Docket Items #11 & 12 BAR #2018-00505 & 2018-00506

BAR Meeting December 19, 2018

ISSUE: Partial Demolition/Capsulation and Addition and Alterations

LOCATION: 507 Prince Street

N E W S T O O P P L A N 1/4"=1'-0"

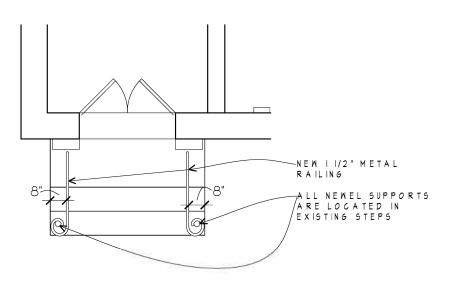
Finally, the applicant is proposing to remove the existing decorative railing on the right side of the front stoop and to install a pair, one at each side, of railings with a simpler, more appropriate design.

The applicant is also requesting approval of the removal of the existing decorative handrail on the right side of the front stoop and the installation of a pair of railings, one at each side, with a simpler and stylistically appropriate design consistent with the *Design Guidelines*, which recommend that:

Handrails were generally not installed on stoops in Alexandria until cast iron stoops and railings became available in the late 19th century and the present railing is likely a mid-20th century "traditional" design constructed with mass produced material. The BAR's current policy states that new handrails may be approved administratively if they are visually minimal, such as a post and rail without balusters, unless a guardrail is required by the building code, so that they do not detract from the extremely handsome Seneca sandstone steps, wood door and architrave around the entry. The handrails were included by staff in the present application to save the owner the additional application fee. Staff supports the new railing design for safety reasons but recommends that the newel for the new handrail be installed in the hole previously created on the east side of the bottom step by the existing railing to minimize further damage to the historic stone steps.

- 1. Install the newel for the new handrail on the east side of the steps in the hole previously created by the existing railing to minimize further damage to the historic stone steps.
